Project	<b>IEEE 802.16 Broadband Wireless Access Working Group</b> < <a href="http://ieee802.org/16">http://ieee802.org/16</a> >		
Title	<b>Remedies for Frame Configuration in 16j Networks</b>		
Date Submitted	<b>2008-05-09</b>		
Source(s)	Senarath Gamini, Israfil Bahceci, Hang Zhang, Peiying Zhu, Wen Tong, Derek Yu, Sun Sheng, Mark Naden  Nortel Networks  3500 Carling Avenue Ottawa, Ontario K2H 8E9	E-mail:	<a href="mailto:gamini@nortel.com">gamini@nortel.com</a>
Re:	IEEE 802.16-08/020: "IEEE 802.16 Working Group Letter Ballot Recirc. #28b: Announcement"		
Abstract	This contribution proposes remedies to the ambiguities of frame configuration in IEEE802.16j/D3.		
Purpose	Discuss and adopt proposed text in TG16j		
Notice	<i>This document does not represent the agreed views of the IEEE 802.16 Working Group or any of its subgroups. It represents only the views of the participants listed in the "Source(s)" field above. It is offered as a basis for discussion. It is not binding on the contributor(s), who reserve(s) the right to add, amend or withdraw material contained herein.</i>

# Remedies for Frame Configuration in 16j Networks

Figure 1 A simple network topology. RS 11 does not need to transmit R-FCH/R-MAP while RS 12 does. The frame configuration for RS 11 and RS 12 can be different.

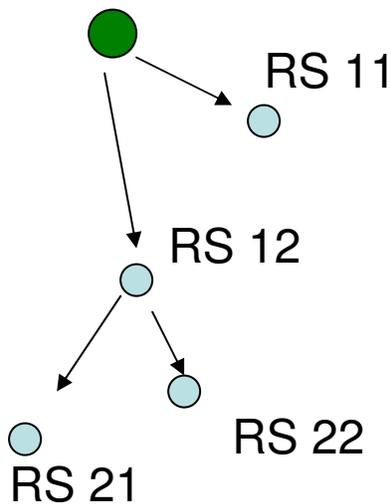
In the current text, RCD message function is not clear. While some TLVs, such as Frame Configuration TLV, may be interpreted as configuration commands for the subordinate RSs, some other TLV, such as R-amble transmission pattern, indicates the system-wide descriptions or parameters. If the RCD is to configure the subordinate RSs this may not work. See for example Figure 1. The subordinate RSs of MR-BS/RS may have different requirements. RS 12 requires an R-zone to transmit to its subordinate RSs, during which period RS 11 can transmit to MSs in an access zone. However, there is already RS config CMD message that is intended for configuring the operational parameters of an RS. Thus, the RCD message should indicate the parameters of the station transmitting the RCD message. With regard to frame configuration, depending on the system load or interference levels, it may be sufficient to provide the RS with the frame structure of its super ordinate station. If it is not sufficient, its frame can be configured by the MR-BS or its super-ordinate RS using RS\_Config-CMD message.
